MODIFICATION APPLICATION

TITLE
ROOF PLAN - PHASE B (REVISED PLAN)

PROJECT
RPAC
26 ALBION STREET WAVERLEY NSW 2024

SCALE: 1: 200 @ A1	JOB No: 1212
CHECKED: PDM	DRAWN: DBV/RM
DRAWING No: 4.55(1B)107	REV B

LEVEL 4 - PHASE B (REVISED PLAN)

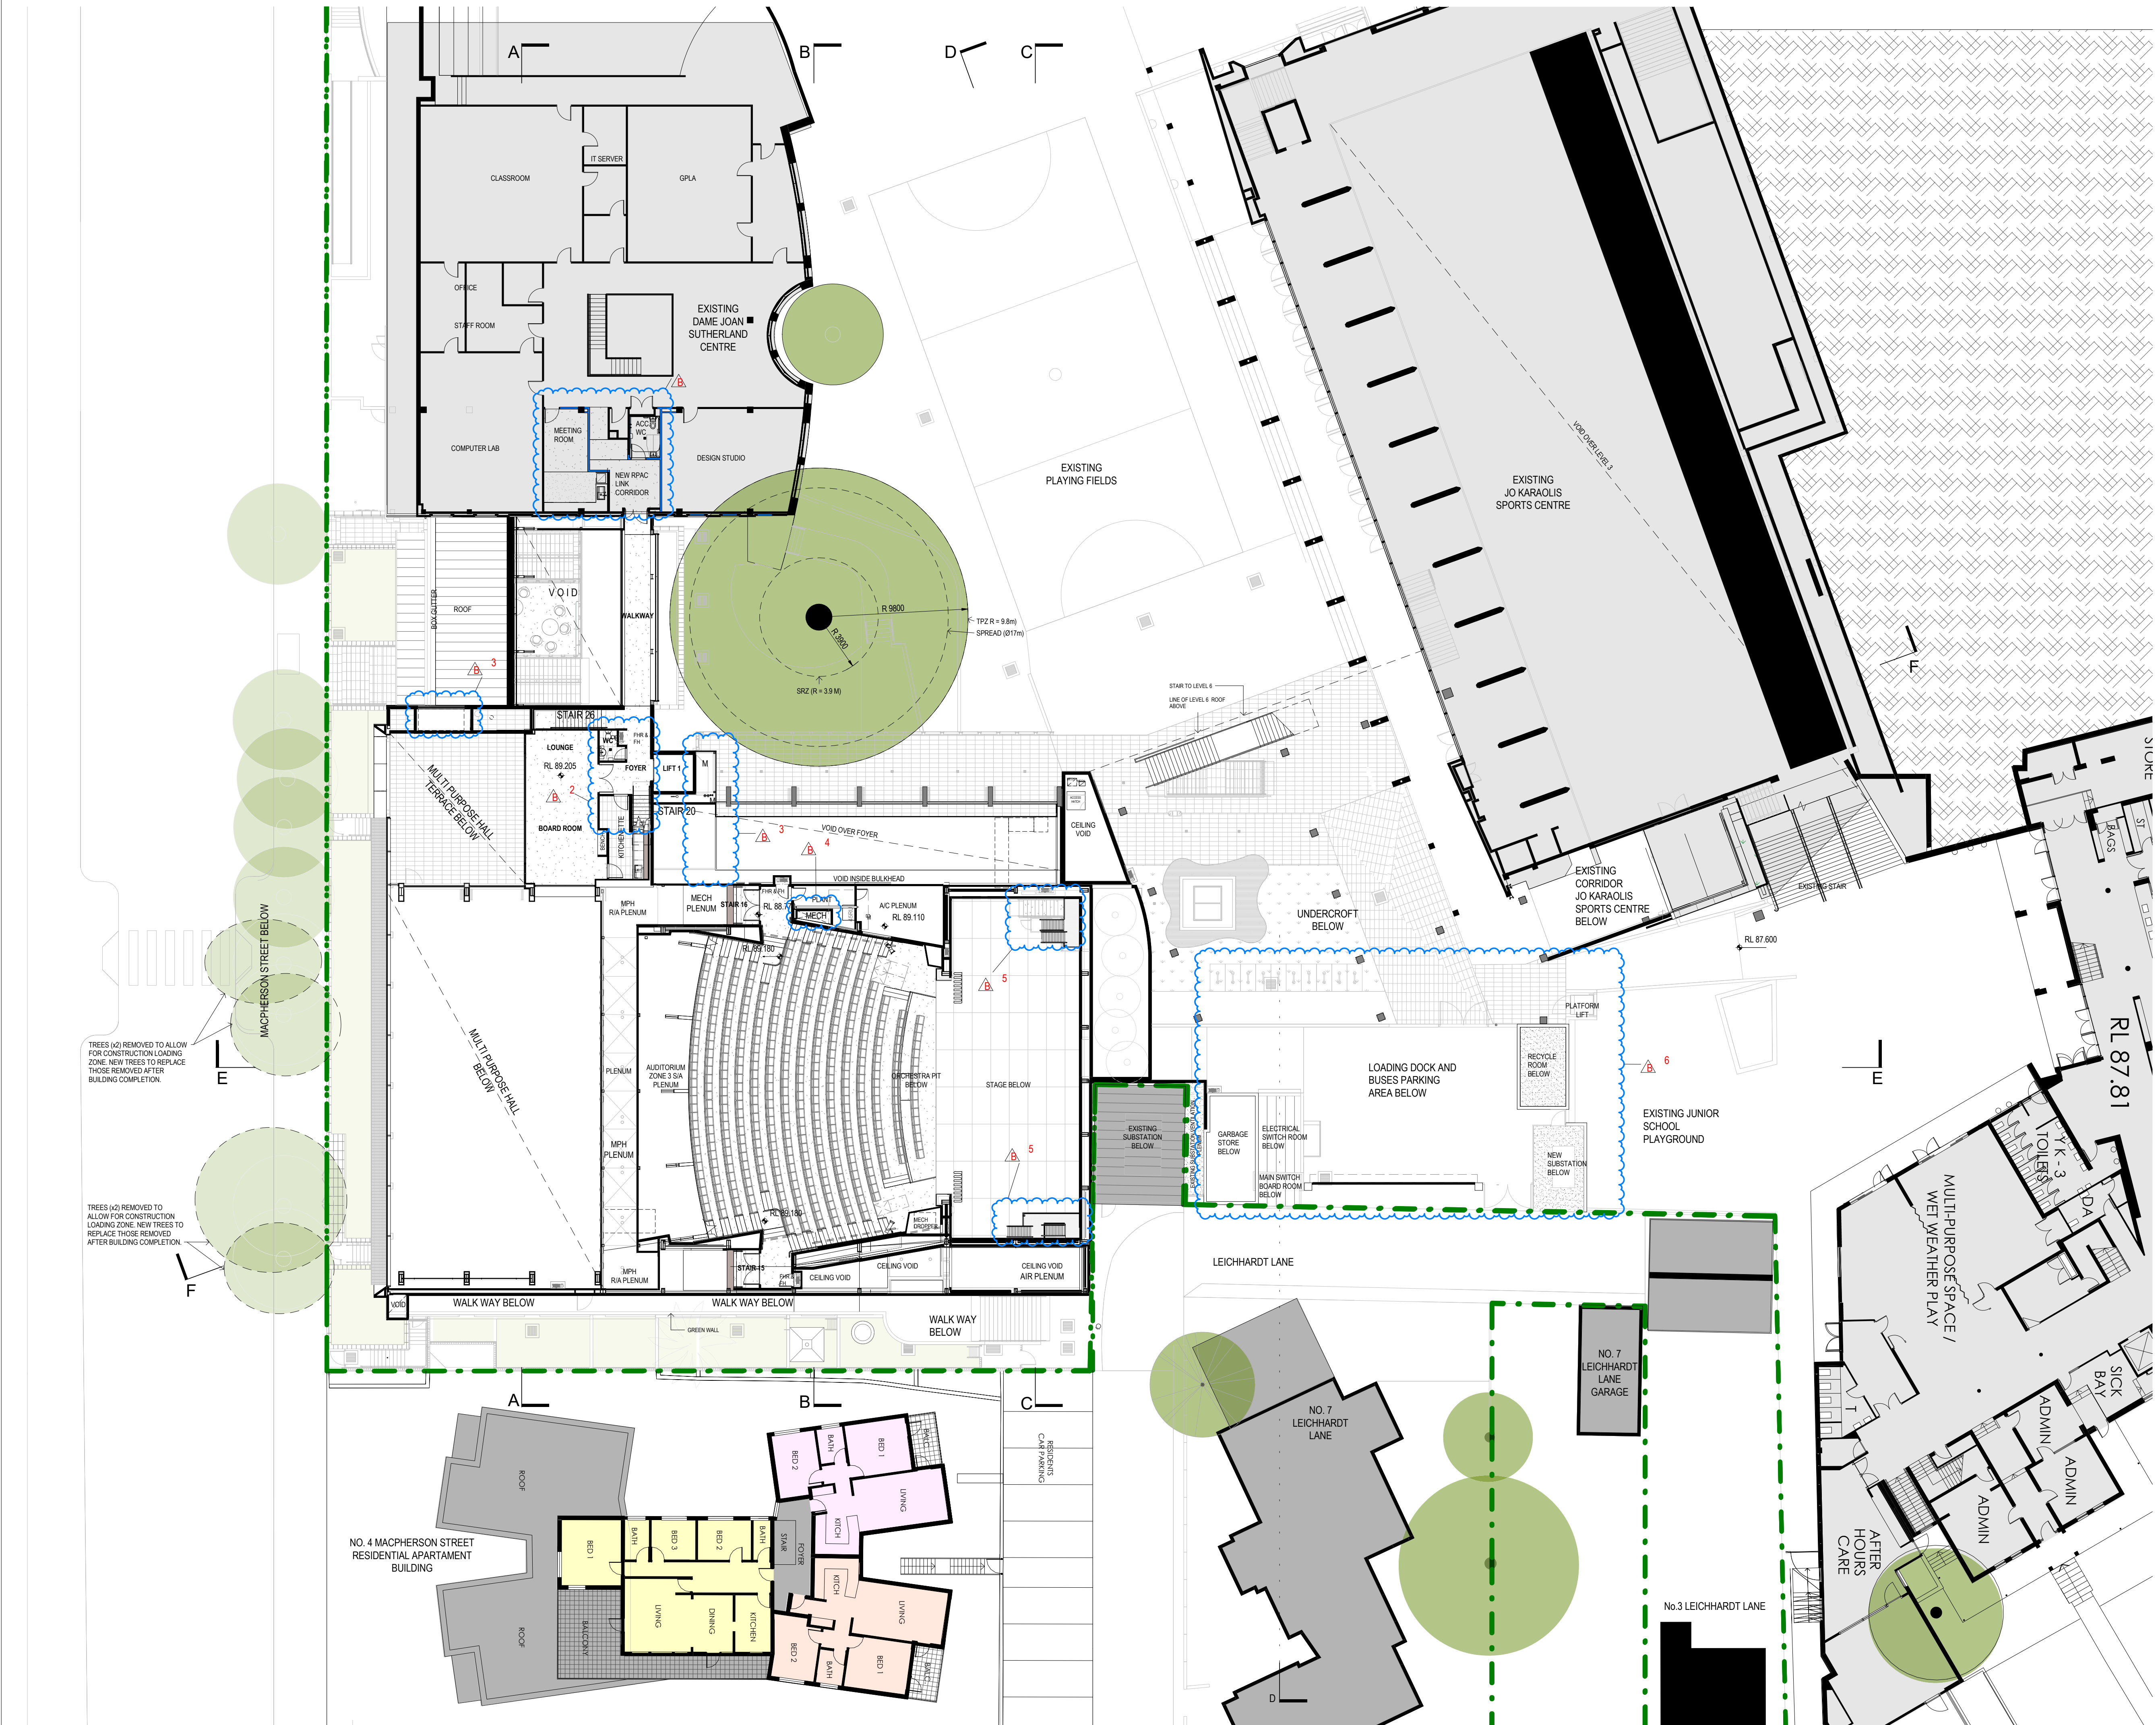
- LIST OF REVISED ITEMS LEVEL 4:
1. NEW SUBSTATION AND REVISED LAYOUT TO SERVICE VEHICLE ZONE
 2. SIZE OF SERVICES RISER ADJUSTED FOR SERVICES RETICULATION
 3. NEW STAIR TO THE STAGE FOR IMPROVED STAGE FUNCTIONALITY
 4. STAIR ORIENTATION REVISED FOR IMPROVED STAGE FUNCTIONALITY
 5. CORRIDOR WIDTH REVISED FOR DDA COMPLIANCE
 6. DOOR SWING REVISED FOR EGRESS COMPLIANCE
 7. REVISED STORE LOCATION.

LEVEL 7 - PHASE A (REVISED PLAN)

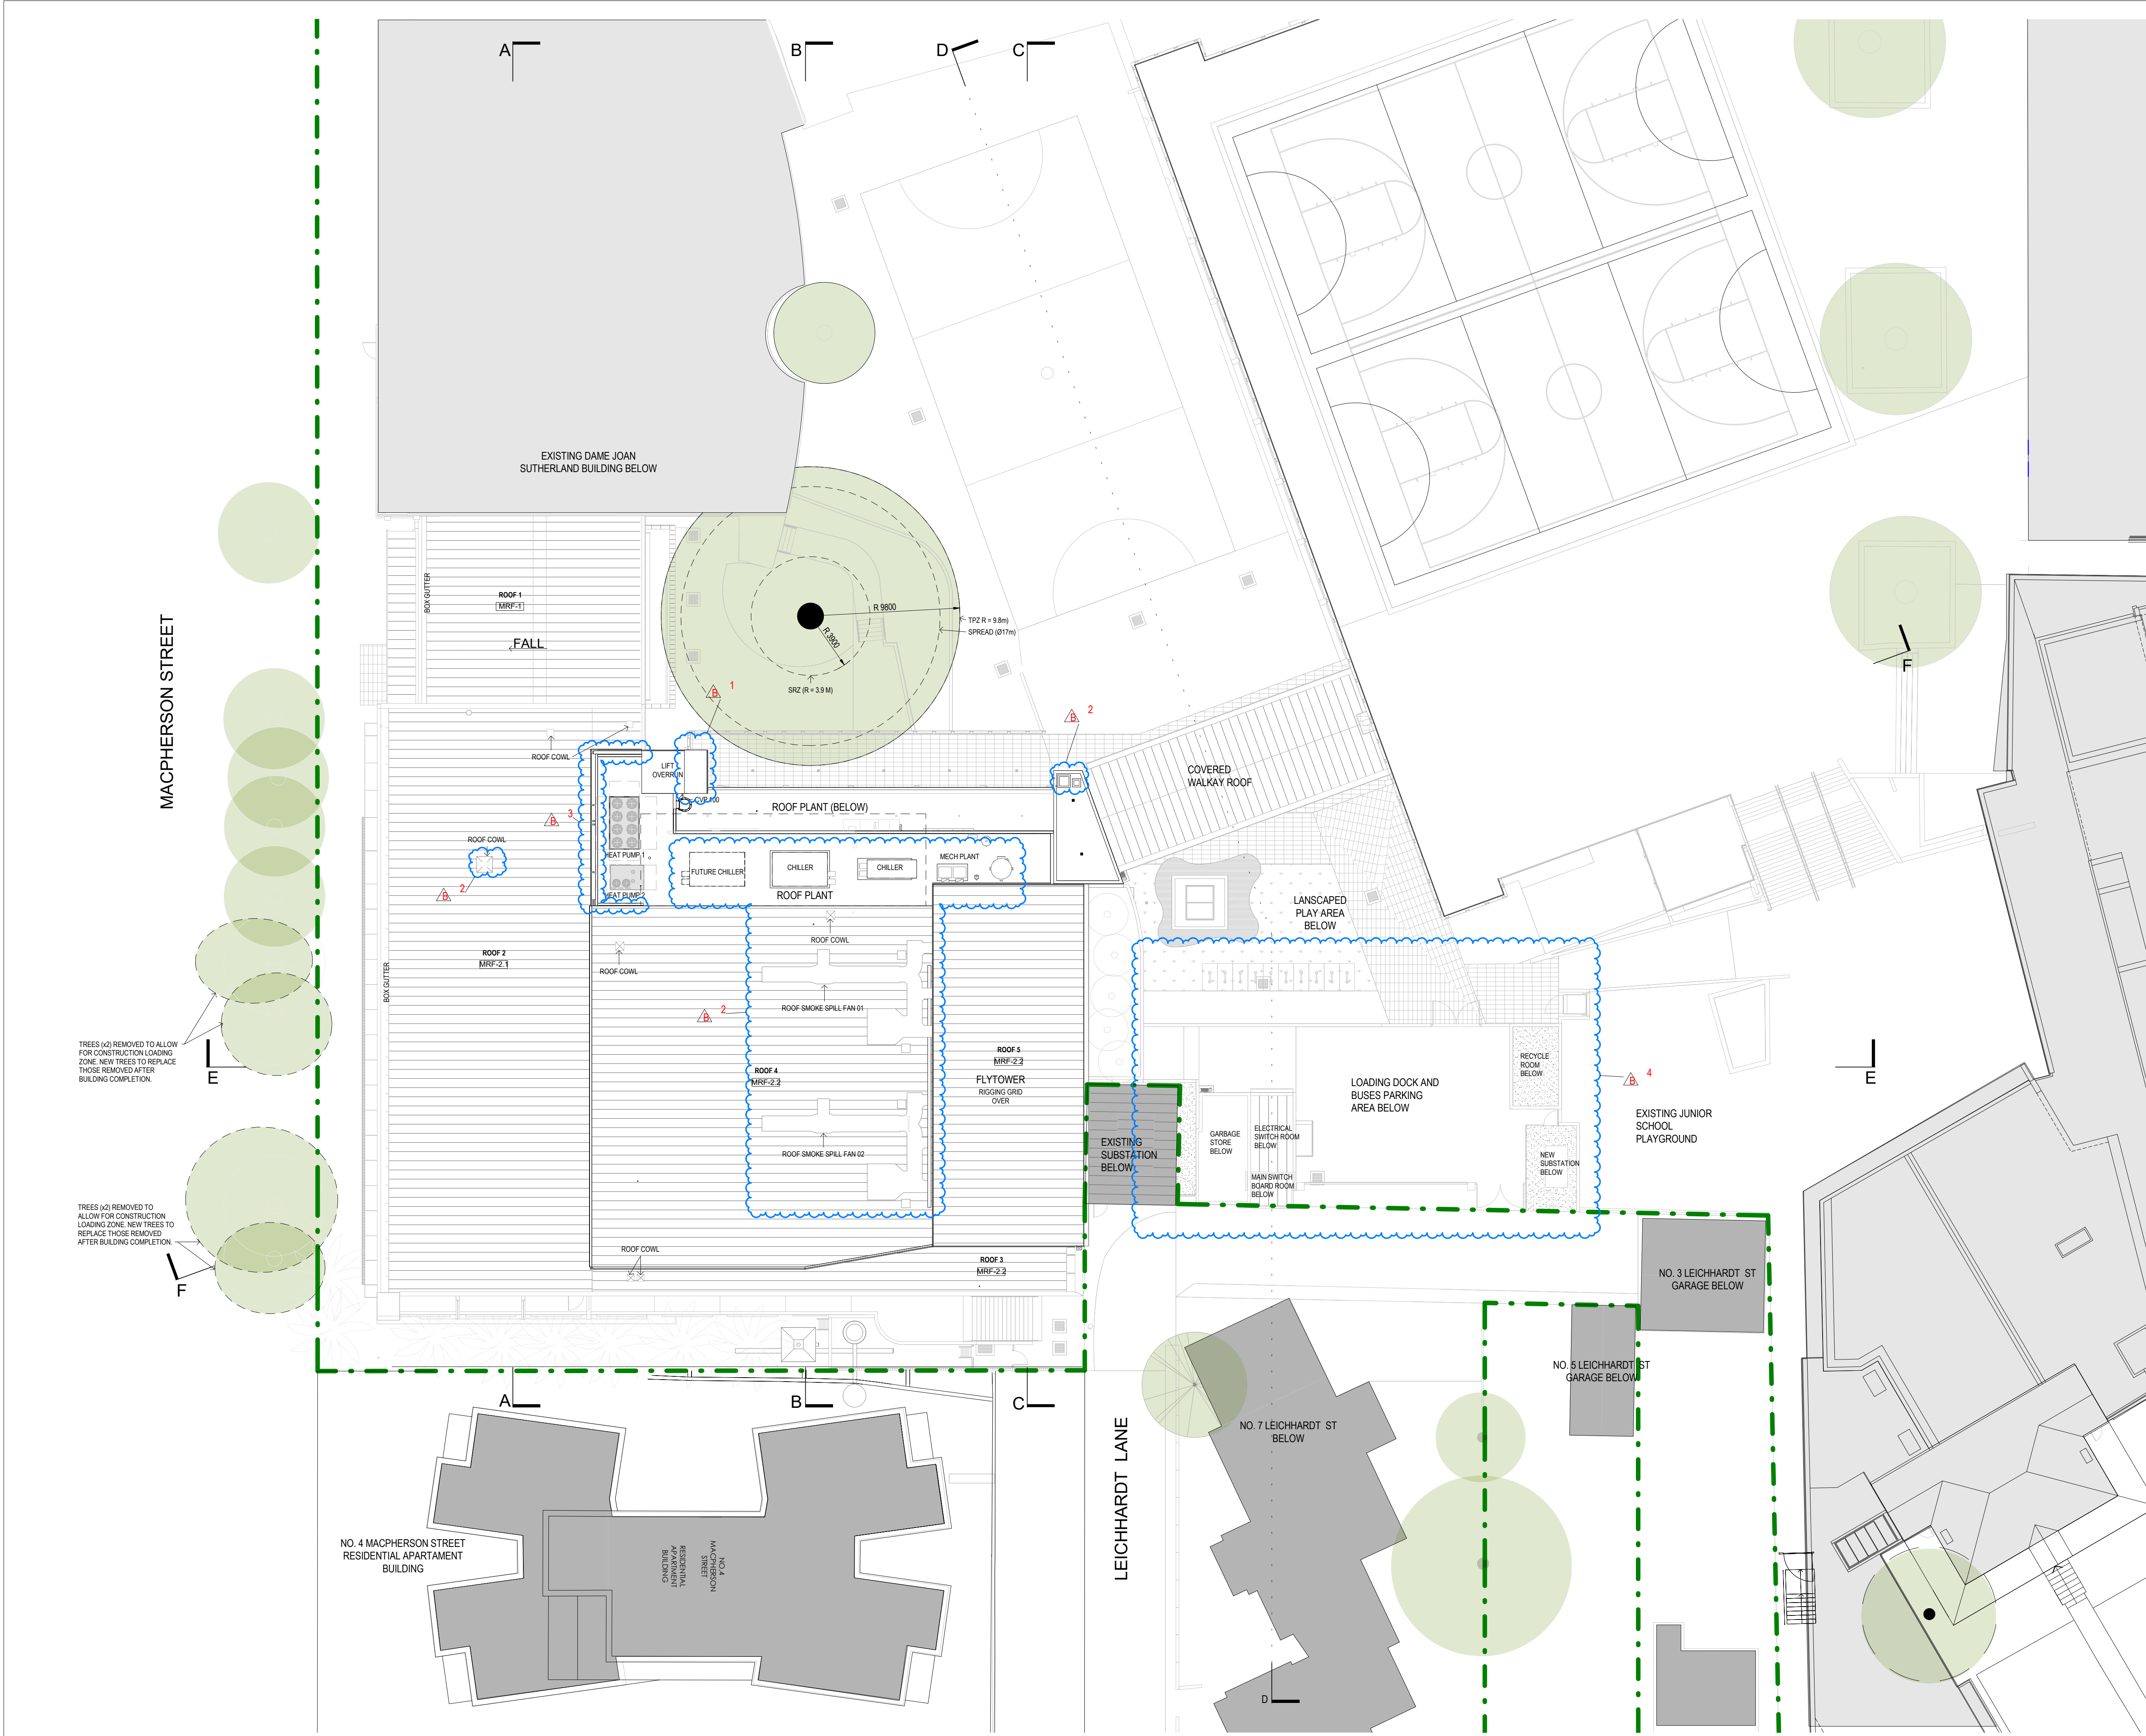
- LIST OF CHANGES LEVEL 7:
- REVISED RISER SIZE FOR SERVICES RETICULATION.
 - MECHANICAL SERVICES AT ROOF PLANT AND ROOF LEVEL UPDATED TO REFLECT FINAL DESIGN.
 - SCREENING TO PLANT FOR COMPLIANCE WITH CONDITIONS OF CONSENT.
 - NEW SUBSTATION LOCATION AND REVISED SERVICE VEHICLE ZONE IN LEVEL 4 (LEVEL BELOW).

LEVEL 4 - PHASE A (REVISED PLAN)

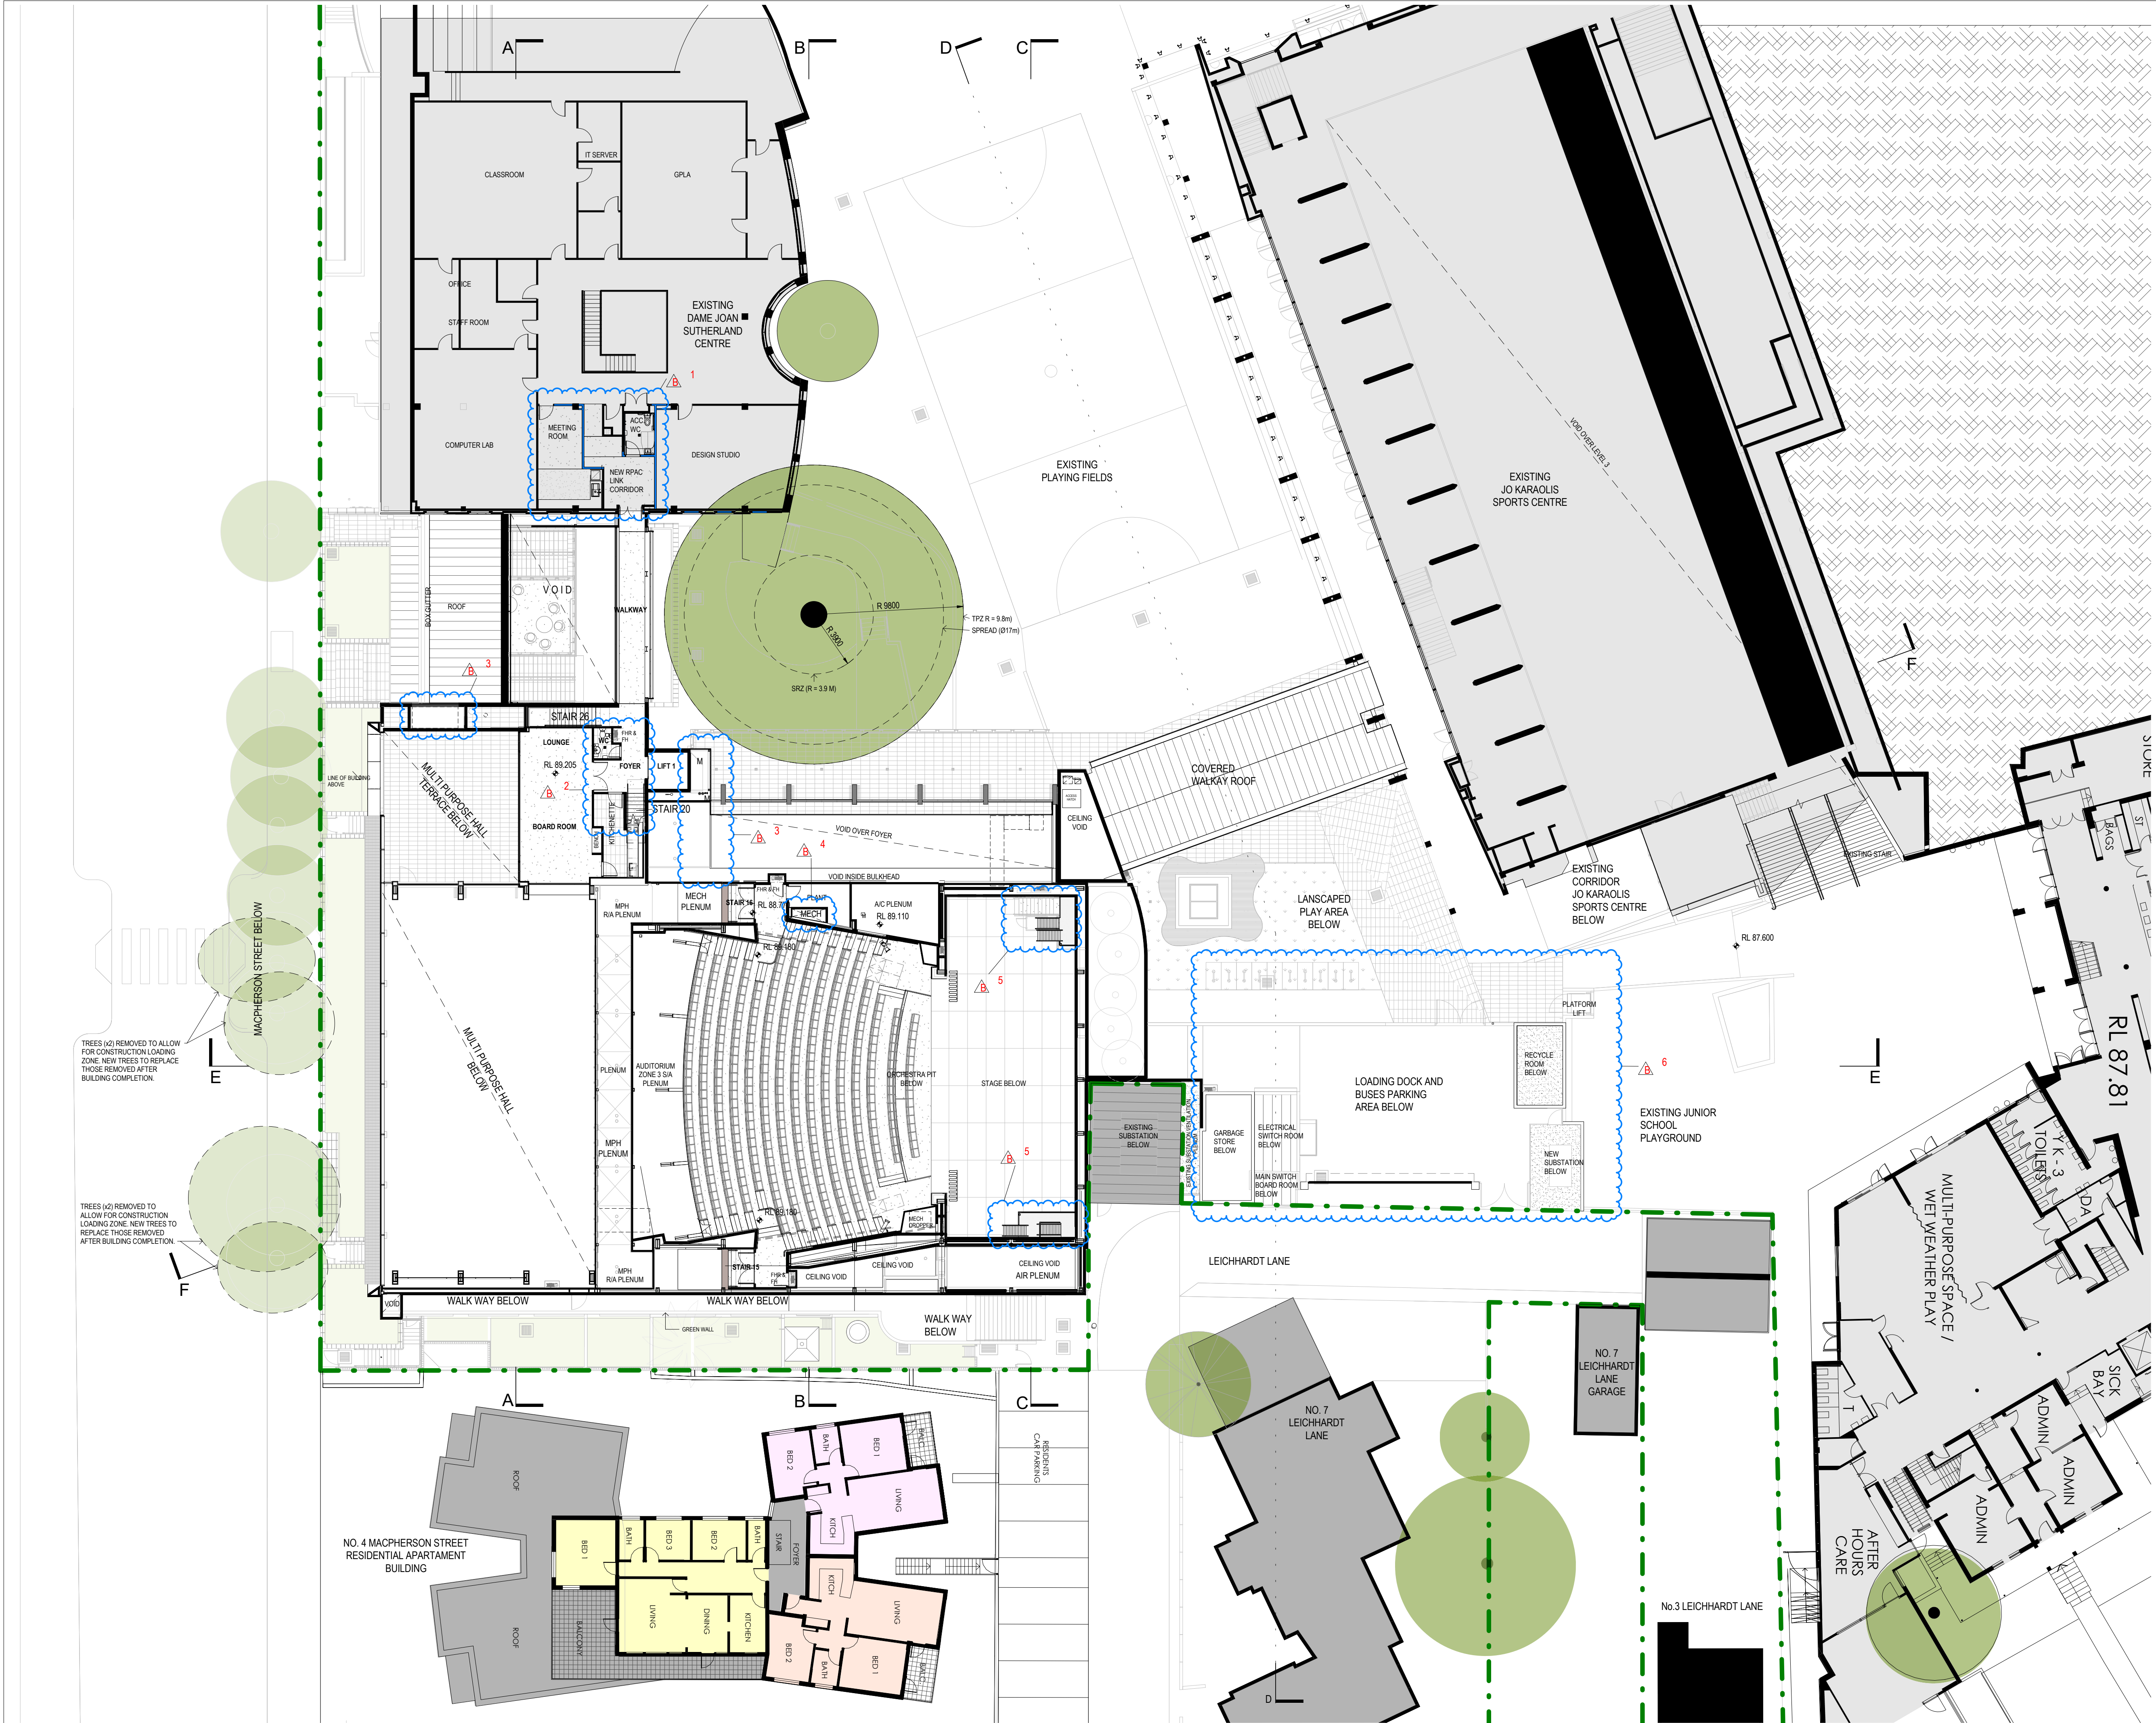
- LIST OF REVISED ITEMS LEVEL 4:
1. NEW SUBSTATION AND REVISED LAYOUT TO SERVICE VEHICLE ZONE
 2. SIZE OF SERVICES RISER ADJUSTED FOR SERVICES RETICULATION
 3. NEW STAIR TO THE STAGE FOR IMPROVED STAGE FUNCTIONALITY
 4. STAIR ORIENTATION REVISED FOR IMPROVED STAGE FUNCTIONALITY
 5. CORRIDOR WIDTH REVISED FOR DOA COMPLIANCE
 6. DOOR SWING REVISED FOR EGRESS COMPLIANCE
 7. REVISED STORE LOCATION.
